INDEPENDENT ORBITER ASSESSMENT ✓

**FMEA/CIL
ASSESSMENT
INTERIM REPORT**

9 MARCH 1988

WORKING PAPER NO. 1.0-WP-VA88003-40

Figure C.13 - CREW EQUIPMENT FMEA/CIL ASSESSMENT

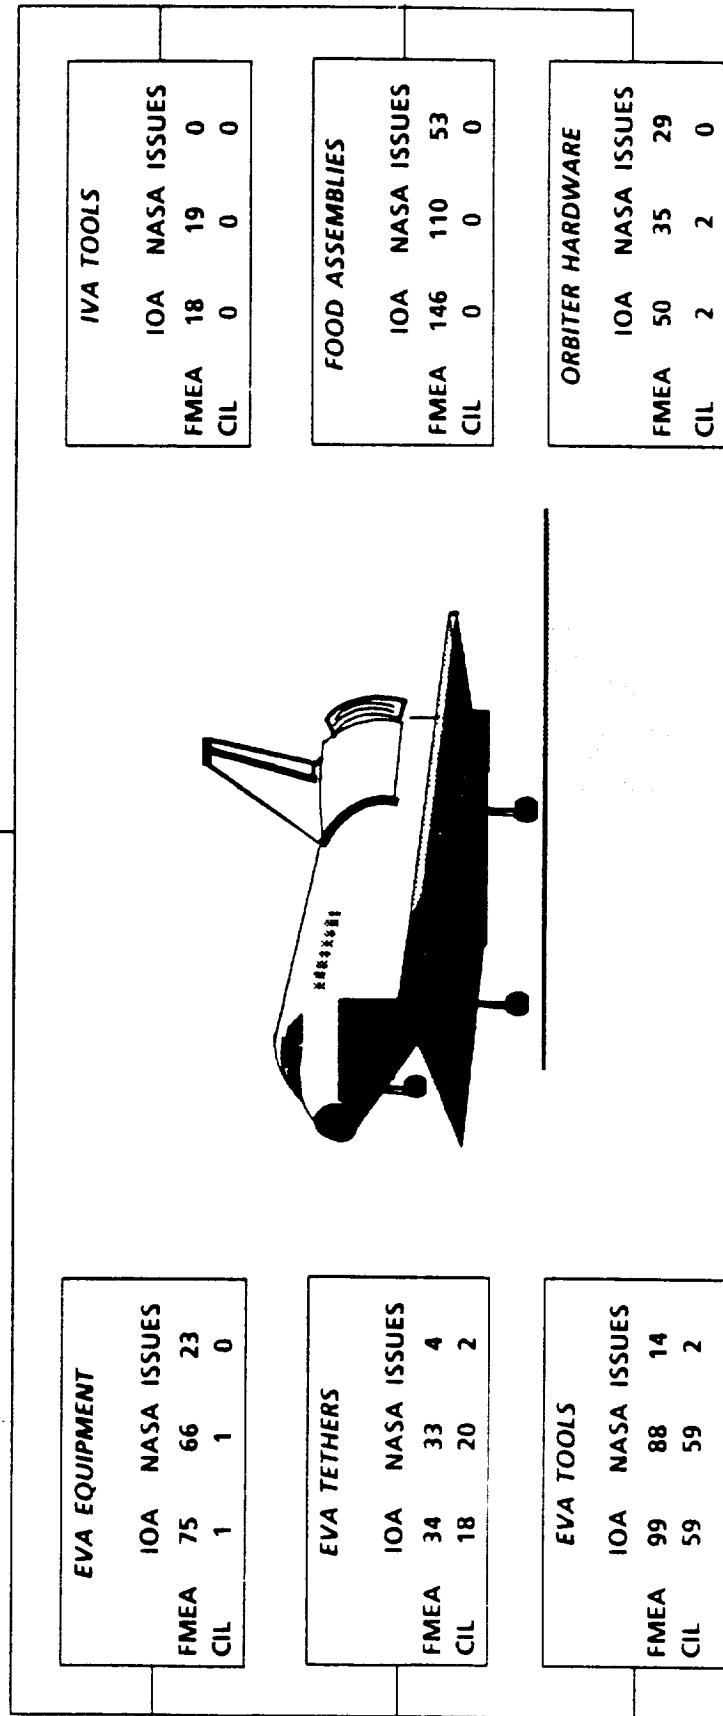
An overview of the quantity of NASA FMEAs assessed, versus the recommended IOA baseline, and any issues identified is presented in Figure C.13.

Figure C.18 - MAS ASSESSMENT

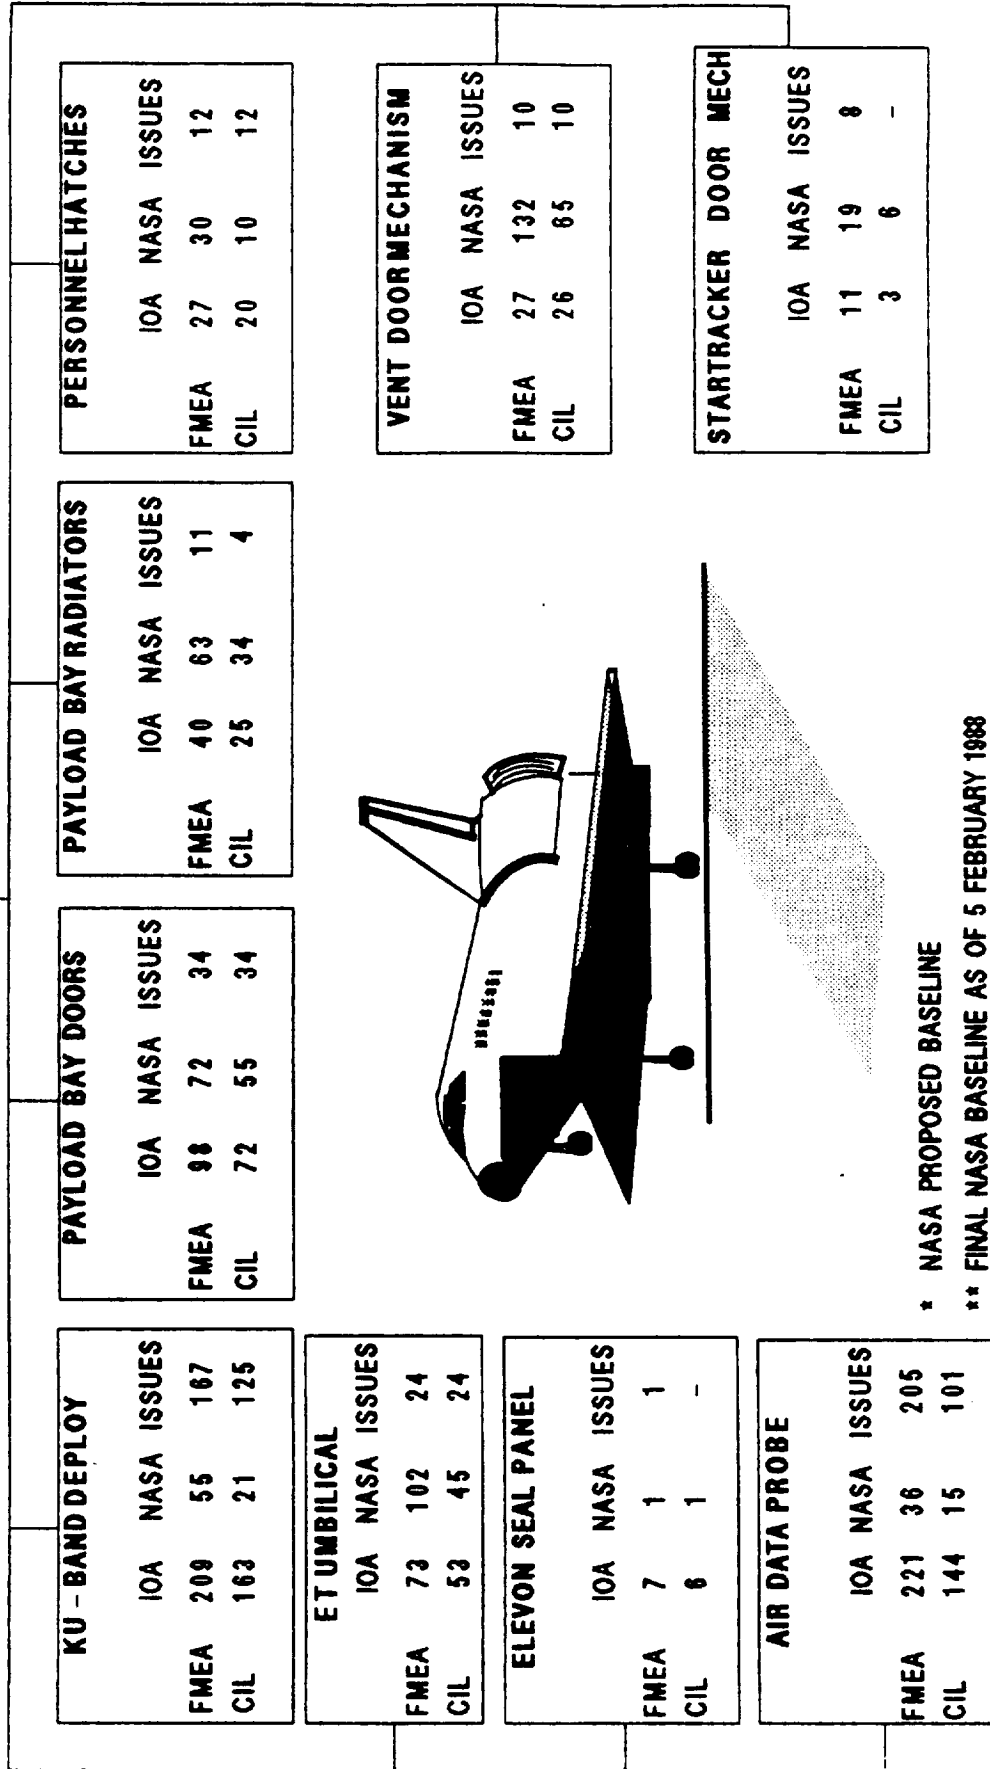
An overview of the quantity of NASA FMEAs assessed, versus the recommended IOA baseline and any identified issues, is presented in Figure C.18. In the analysis and assessment report, the MAS was divided into nine sections according to hardware and function. Each of these sections are identified, with summary assessment results, in Figure C.18.

The IOA analysis of the MAS hardware initially generated 685 failure mode worksheets and identified 476 Potential Critical Items (PCIs) before starting the assessment process. In order to facilitate comparison, 28 additional failure mode analysis worksheets were generated. These analysis results were compared to the proposed NASA Post 51-L baseline (5 February, 1988) of 510 FMEAs and 252 CIL items using available NASA FMEA/CIL data. The discrepancy between the number of IOA and NASA FMEAs can be explained by the different approach used by NASA and IOA to group failure modes. In many cases, multiple IOA FMEAs were mapped to a single NASA FMEA. The MAS assessment identified a total of 472 issues. Many of these issues resulted from failures identified by IOA which could not be matched to available NASA FMEAs. It is believed that other issues resulted from IOA use and interpretation of NSTS-22206 differing slightly from criteria used by RI and NASA, and a difference in criticality assignments for a particular hardware item or function.

Figure C.19 - MMU FMEA/CIL ASSESSMENT

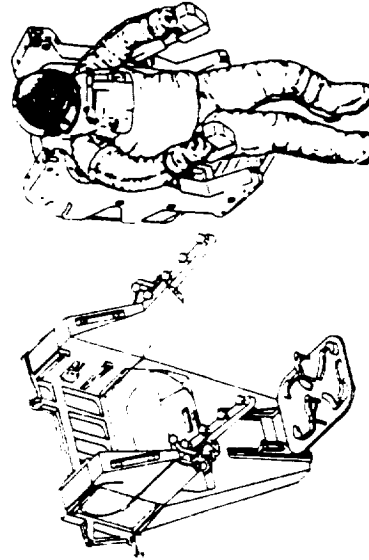
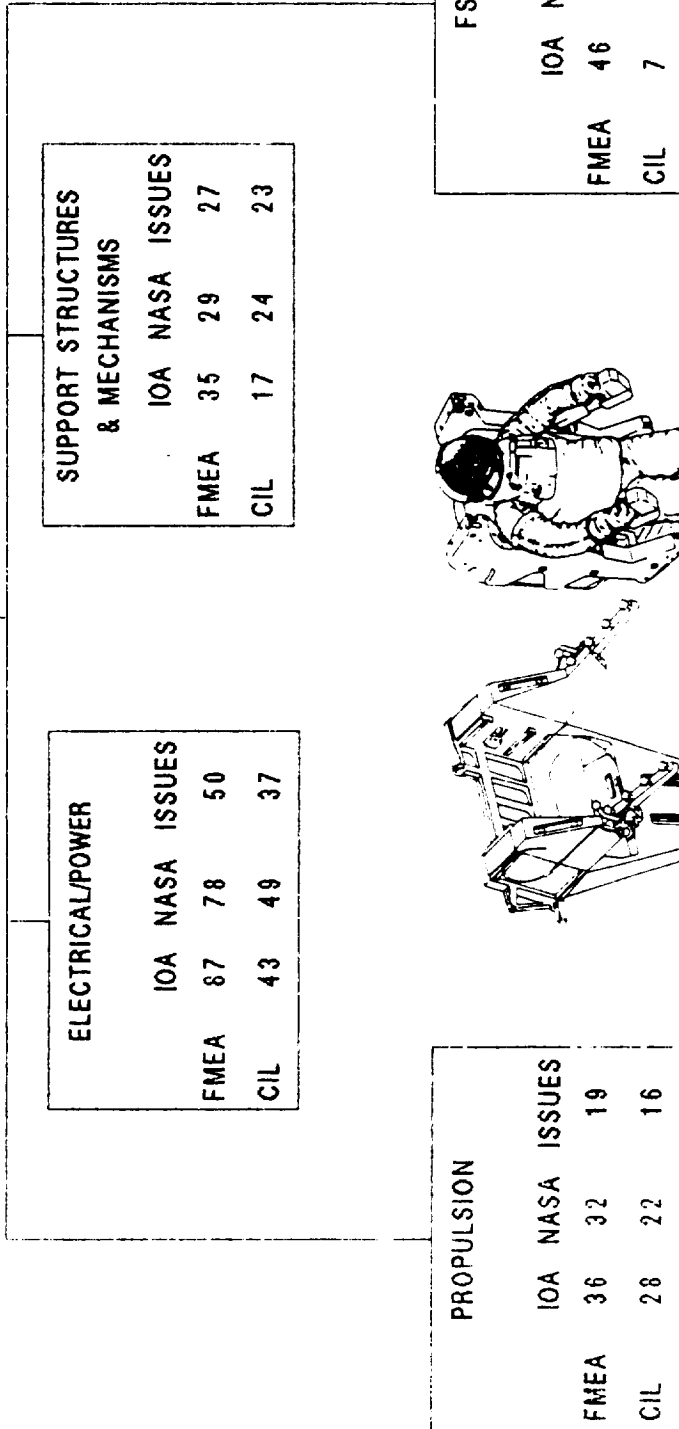
The IOA analysis of the MMU hardware initially generated 136 failure mode worksheets and identified 69 PCIs before starting the assessment process. In order to facilitate comparison, 57 additional failure mode analysis worksheets were generated. These analysis results were compared to the proposed Martin Marietta Post 51-L baseline of 179 FMEAs and 110 CIL items. Upon completion of the assessment, 121 of the 204 IOA failure modes remained as issues to be resolved. A summary of the FMEA/CIL counts for IOA and NASA is provided in Figure C.19, and some of the significant issues follow.

The MMU PREP and POST-OPS definitions were not too clear, and it was consequently difficult to match their criticalities. IOA considered every MMU activity to begin with PRE-OPS activities and end with POST-OPS activities prior to the start of the next MMU OPS. The Martin Marietta definition seems to suggest that the PREP activities start with the first MMU PRE-OPS and stop after the last MMU OPS activity. The period after the last planned MMU OPS will then be POST-OPS.

Figure C.20 - NWS ASSESSMENT

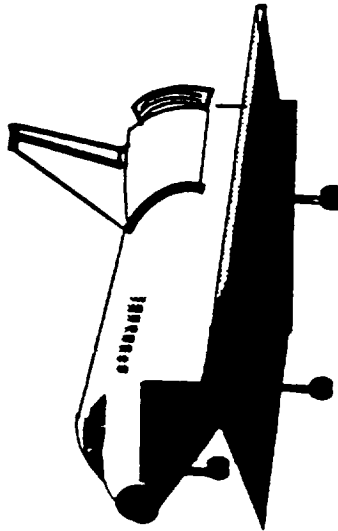
The IOA analysis of the NWS hardware initially generated 78 failure mode worksheets and identified 42 Potential Critical Items (PCIs). As a result of the assessment process, 15 NWS

failure mode worksheets were deleted and an additional 5 analysis worksheets were generated and added to the assessment package. The assessment comparison also gave rise to 14 issues between the IOA NWS analysis and the corresponding NASA FMEAs (Fig. C.20).

Figure C.22 - ARS ASSESSMENT

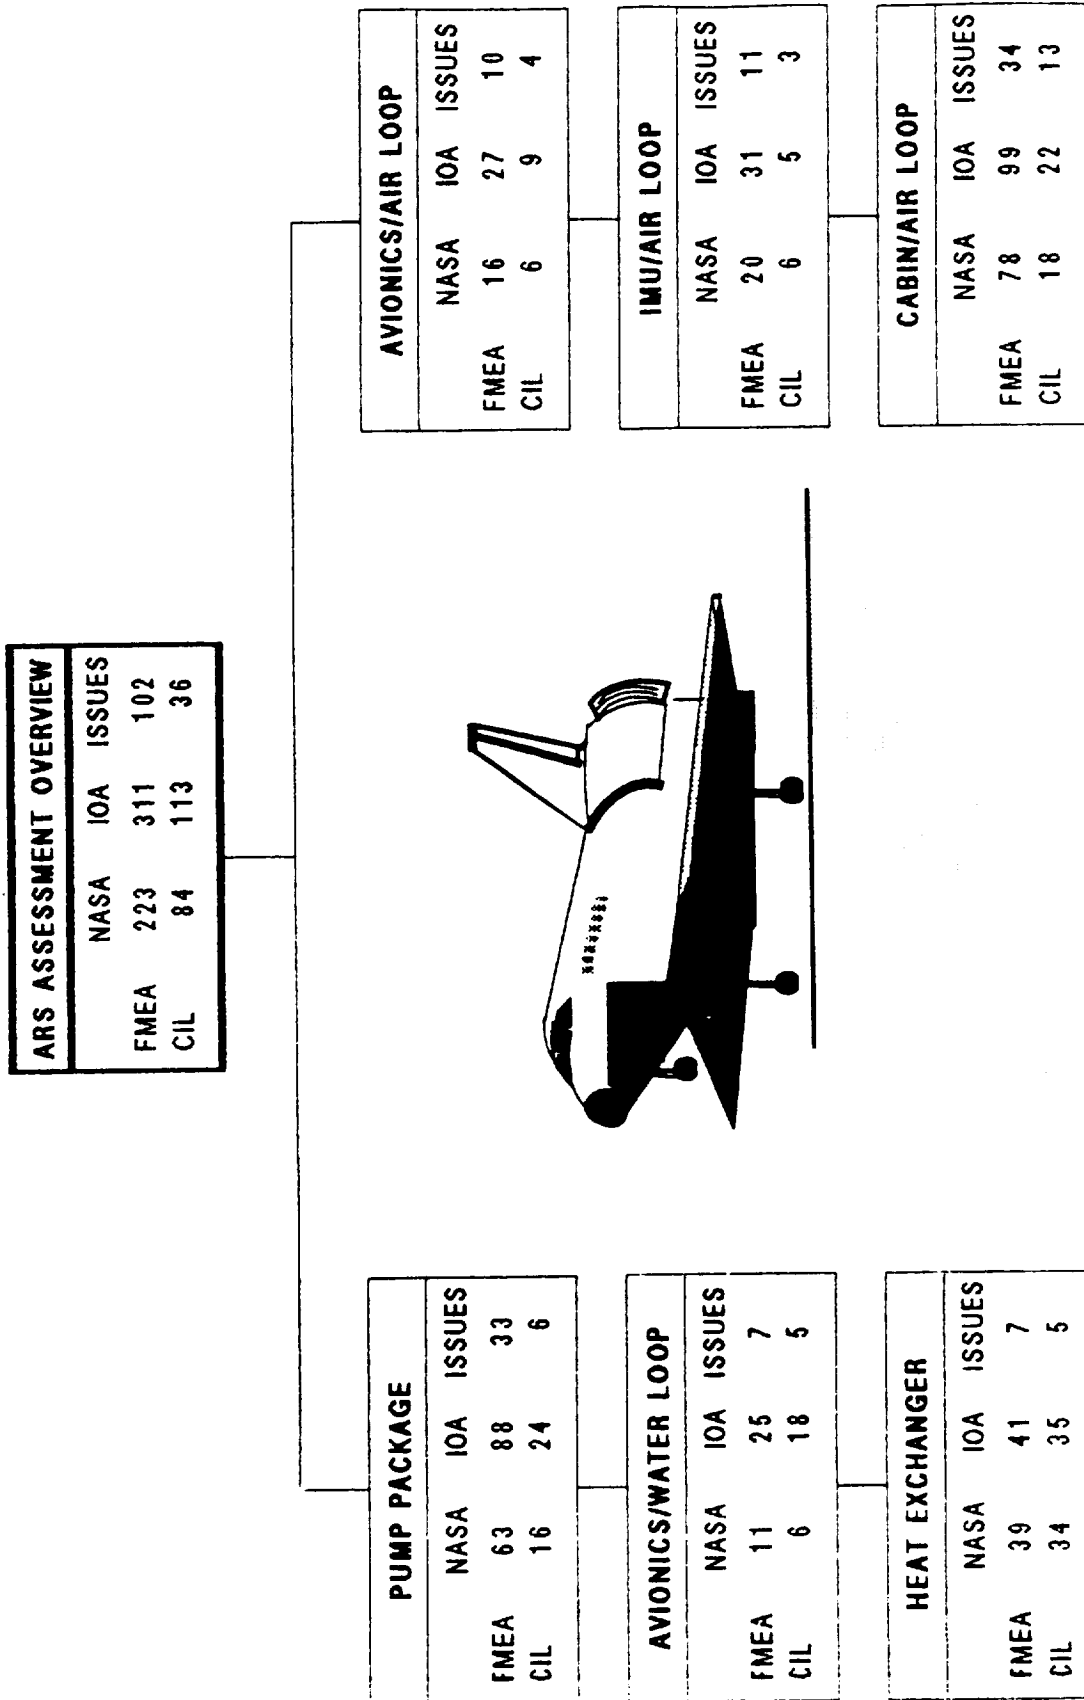
The ARS Assessment Overview figure C.22 lists the total number of IOA and NASA FMEA and CIL items, along with a comparison of the discrepancies or issues identified during the assessment. For analysis purposes, the ARS was divided into 6 subsystems: the Pump Package, the Avionics/Water Loop, the Heat Exchanger, the Avionics/Air Loop, the IMU/Air Loop and the Cabin/Air Loop.

The IOA analysis of the ARS hardware initially generated 245

failure mode worksheets and identified 84 PCIs prior to starting the assessment process. In order to facilitate comparison, 74 additional failure mode worksheets were generated and 8 of the original worksheets were deleted. Thus, the final IOA analysis identified 311 FMEAs and 84 potential CILs. The analysis results were compared to the available NASA FMEA/CIL data. A total of 223 NASA FMEAs and 84 NASA CILs were identified. The discrepancy between the number of IOA and NASA FMEAs can be explained by the different approaches used by NASA and IOA to group failure modes. This resulted in multiple IOA FMEAs being mapped to a single NASA FMEA. However, every NASA FMEA is mapped to at least 1 IOA worksheet.
